DEPARTMENT REPORT

HEARING DATE: 1/13/2026
 TO: Mayor & City Council
 FROM: Sonya Allen, Associate Planner
 208-884-5533
 sallen@meridiancity.org
 APPLICANT: Kimley-Horn
 SUBJECT: SHP-2025-0008
 Vanguard Village East
 LOCATION: Generally located at the southeast corner of W. Grand Mogul Dr. and S. Umbria Hills Way, in the southeast 1/4 of Section 15, T.3N., R.1W. (Parcel # R8956280800)

B. Short Plat (date: 10/21/2025)

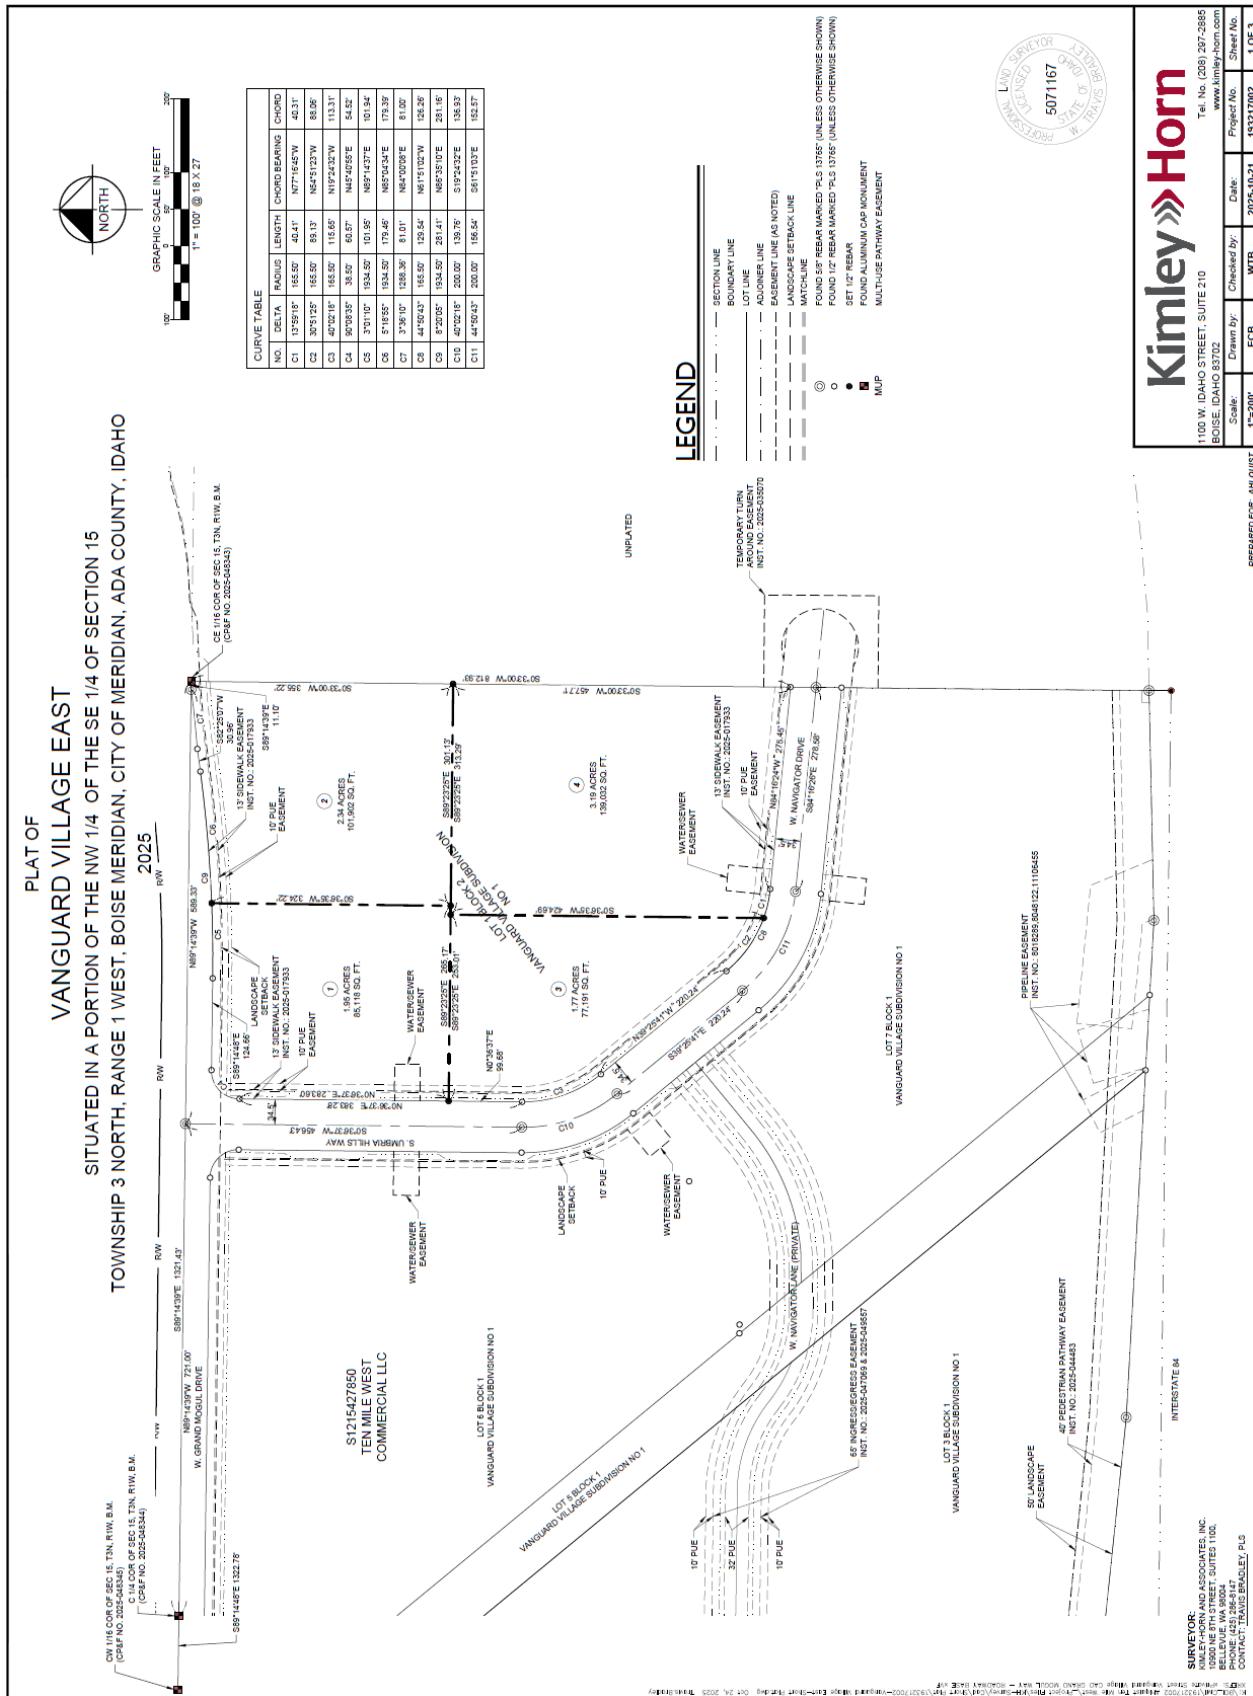
*Permanent dedicated buffer easements, maintained by the property owner or business owner's association, are required at the minimum width noted, measured from back of curb. The proposed plat depicts a landscape setback along W. Grand Mogul Dr. – **dedicated buffers should also be depicted on the plat along S. Umbria Hills Way and W. Navigator Dr. All street buffer landscaping is required to be installed with the subdivision improvements for Vanguard Village Subdivision No. 1 as shown on the approved landscape plan in Section VII.C.***

Note: The line symbol for the internal boundary of the landscape setback line doesn't appear to match that in the Legend for such; revise accordingly.

- a. Depict the boundary of the subdivision in a heavier line type to delineate the boundary. The boundary line in the Legend is missing the symbol.
 - b. Depict lot lines in the line type depicted in the Legend.

- c. Include a note granting cross-access easements between all the proposed lots for internal cross-access and access via S. Umbria Hills Way and W. Navigator Dr.; or record a separate easement granting such and reference the recorded instrument number in a note on the plat. If parking will be shared between the proposed lots, a cross-parking agreement/easement should also be recorded and/or noted on the plat.

- d. A blanket cross-access easement shall be granted to the property to the east (Parcel #S1215417409) per UDC 11-3A-3A.2 via a separate recorded easement or a note on the plat.

- e. Depict dedicated street buffers along S. Umbria Hills Way and W. Navigator Dr. in accord with UDC Table 11-2B-3 and 11-3B-7C (minimum 20-feet measured from back of curb). Note: The line symbol for the inner boundary of the landscape setback line doesn't appear to match that in the Legend for such; revise accordingly.

- f. Note #3: Delete note (Note #5 includes the same information)
 - g. Note #4: Include the recorded instrument number of the CC&R's.
 - h. Note #5: Include the recorded instrument number of the development agreement (i.e. #2024-050341).

- i. Note #7: Include information in the blanks pertaining to maintenance of the on-site landscaping and surface water rights.
 - j. Note #11: Include the recorded instrument number of the ACHD temporary license agreement.

- k. Note #12: Include information pertaining to who will own and maintain the pressure irrigation system.
 - l. Note #13: Include the recorded instrument number of the license agreement.

- m. Note #14: Include the recorded instrument number of the irrigation association license agreement.
- n. Note #15: Include the information in the blanks pertaining to the delivery of irrigation water.
